TYPE NO <b>7100 ES – 7100 FB</b>	TYPE <b>Coffee Vending Machines</b>	T.I. NO <b>07 - 2015</b>				
SERIAL NUMBERS AFFECTED	Serial Number <b>52011349 / 52511569 7100 ES</b> <b>52511489 7100 FB</b>	ISSUED BY <b>Documentation/N&amp;W Valbrembo</b>				
SUBJECT <b>TASTE IMPROVEMENTS FOR HOT WATER</b>		ISSUED FOR (X): <table border="1"> <tr> <td>Action</td> <td></td> </tr> <tr> <td>Information</td> <td><b>X</b></td> </tr> </table>	Action		Information	<b>X</b>
Action						
Information	<b>X</b>

To improve the hot water quality selections

### A. MODIFICATIONS for 7100 ES:

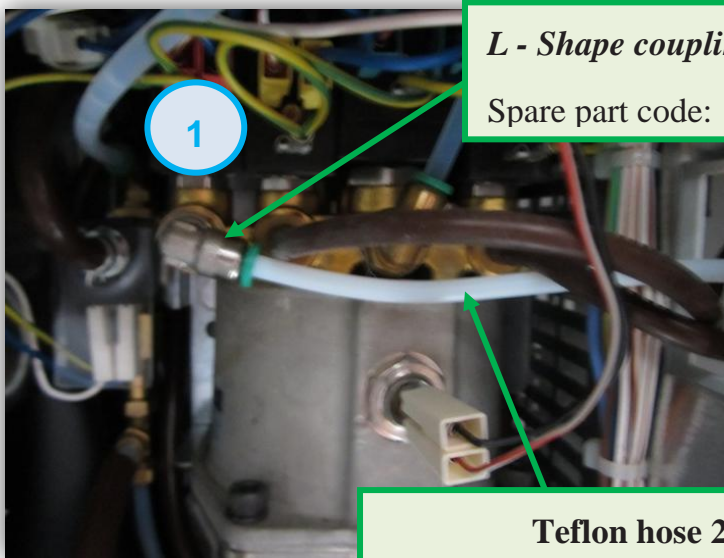
The silicone hoses that connect the boiler outlet (**pos. 1**) to hot water dispensing spout (**pos. 3**) are replaced by two **teflon** hoses: (**pos. 1** → **pos. 2**) + (**pos. 2** → **pos. 3**)

In addition it's required to replace on the manifold the hose – fitting and its OR with a **L – shape coupling**.

Three pieces of blue silicone hoses are also required (see following page).

**Teflon hose 2.5x5 – Lg. 420 mm**

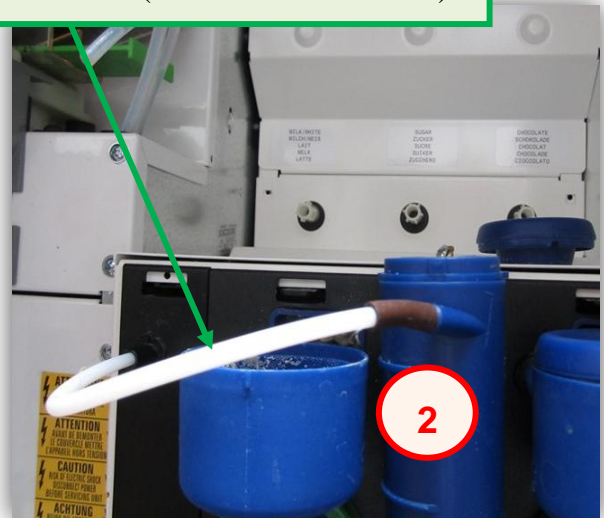
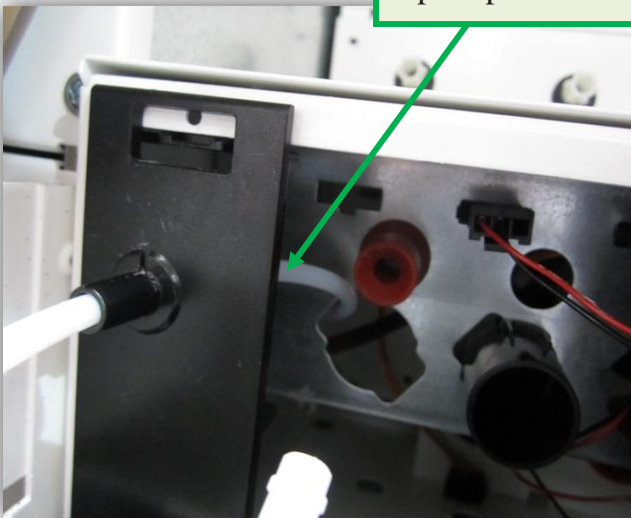
*L - Shape coupling 5 x 1/8*

Spare part code: **0V2509**

Spare part code: **252659** (minimum order 1 m)

**Teflon hose 4x6 – Lg. 210 mm**  
 Spare part code: **255539** (minimum order 1 m)

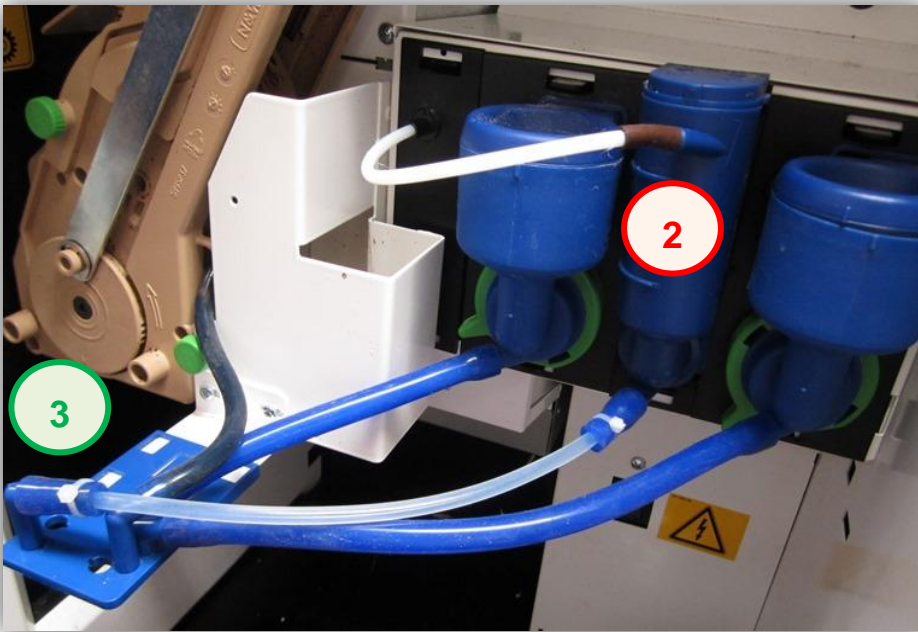
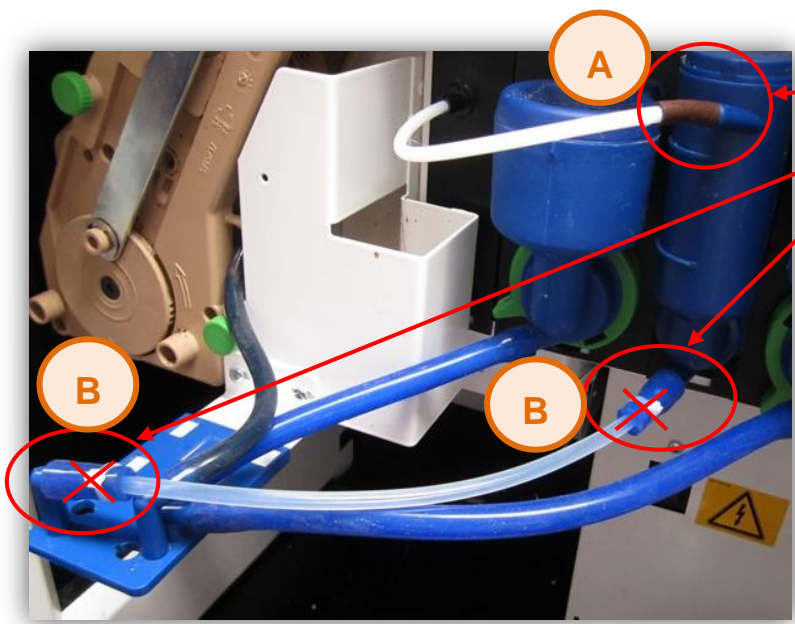
Note: it will be used a **blue piece**.  
**Tie-rods** are not necessary.

**Three pieces of blue silicone hoses.**  
**A.** Silicone hose **3x6 – Lg. 25 mm**  
 S.P. code: **254566** (min. order 1m)  
**B.** Silicone hose **5x9 – Lg. 25 mm**  
 S.P. code: **254565** (min. order 1m)

## B. MODIFICATIONS for 7100 FB:

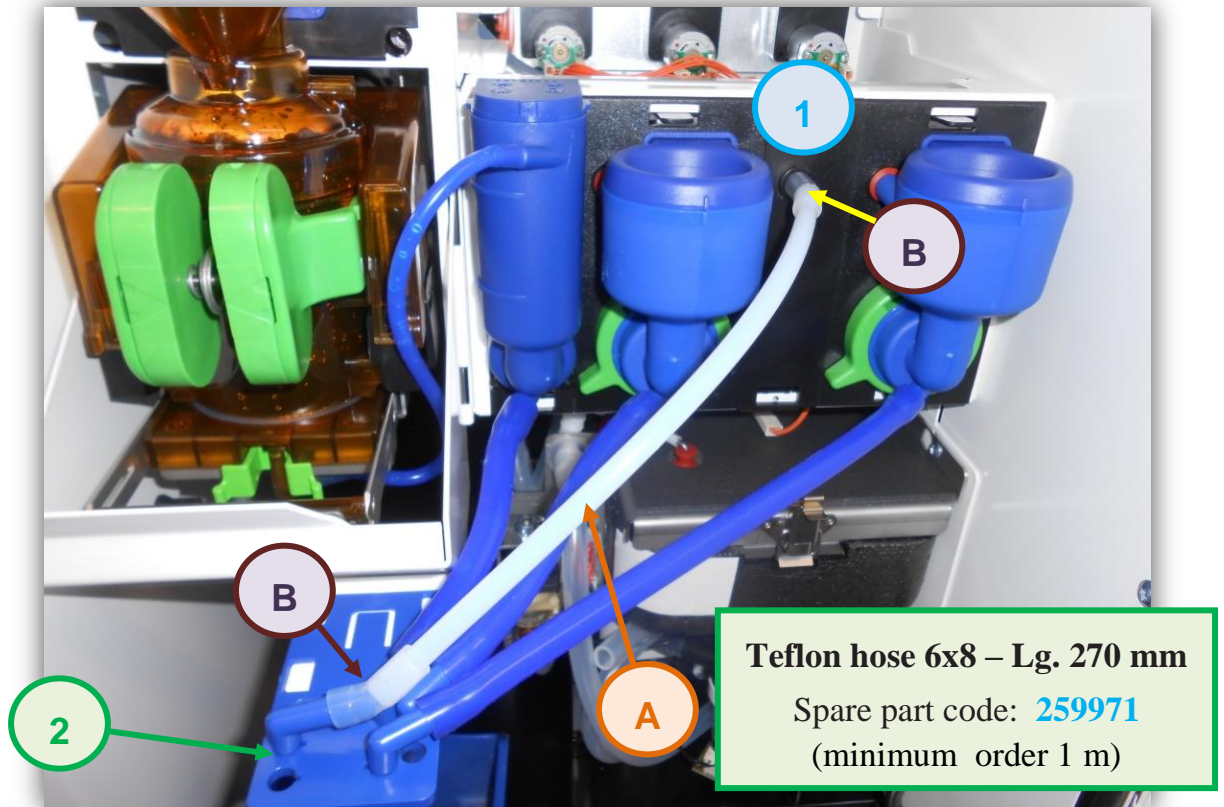
The silicone hose that connects the instant module outlet (**pos. 1**) to hot water dispensing spout (**pos. 2**) is replaced by a **teflon** hose:

Machines concerned by this modification from S/N **52511489**

For the machines prior to the above mentioned serial number it's possible to implement the modification by ordering the parts below:

- Teflon hose **6x8 – Lg. 270 mm** **A** Spare part code: **259971**  
(min. order 1 m)
- **N. 2** Blue silicone hose **12x6,7 – Lg. 25 mm** **B** Spare part code: **256093**  
(min. order 1 m)
